# UNITED STATES PATENT AND TRADEMARK OFFICE

APPLICATION NO.	FILING DATE	FIRST NAMED INVENTOR	ATTORNEY DOCKET NO.	CONFIRMATION NO.
10/633,450	07/31/2003	Robert D. Harty	0006/00921	4683
27197 7590 06/26/2009 MICHAEL J. CHERSKOV 300 NORTH STATE STREET SUITE 5102 CHICAGO, IL 60654				
EXAMINER LEWIS, KIM M				
ART UNIT		PAPER NUMBER		
3772				
MAIL DATE		DELIVERY MODE		
06/26/2009		PAPER

### Office Action Summary

**DETAILED ACTION**

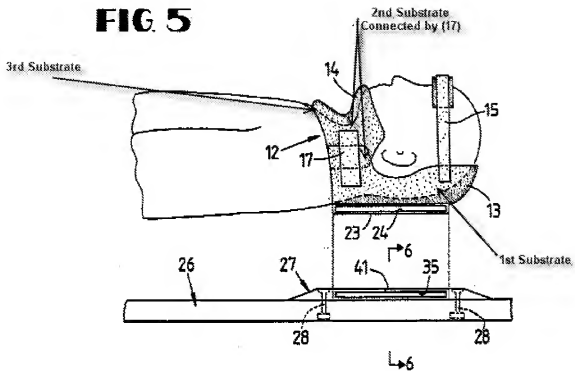
As regards claim 12, Carroll, as can be seen from the attached Fig. 5, discloses a device to immobilize the head, neck and upper torso of a patient, the device comprising: a) a first substrate adapted to support for supporting the back of the patient's head; b) a second substrate in communication with the first substrate, whereby the second substrate is adapted to encircle the patient's neck; c) a third substrate in communication with the second substrate, whereby the third substrate is adapted to contacts the patient's chest; and d) one or more means (23) for removably securing the device to a backboard wherein the securing means comprises an elongated substrate having a first end (top end) attached to the first substrate of the device and a second

end (including the opening and bottom end) Radapted to be removably fastened to the backboard.

Re. claim 13, note Fig. 2, which discloses the geometric shape of (23) and the opening in frame (27) in which (23) mates with.

Re. claim 14, note frame (27) removable from the backboard.

Regarding claim 6, Carroll, as can be seen from the attached Fig. 5, discloses a device to immobilize the head, neck and upper torso of a patient, the device comprising: a) a first substrate adapted to support for supporting the back of the patient's head; b) a second substrate in communication with the first substrate, whereby the second substrate is adapted to encircle the patient's neck; and c) a third substrate in communication with the second substrate, whereby the third substrate is adapted to contact the patient's chest.
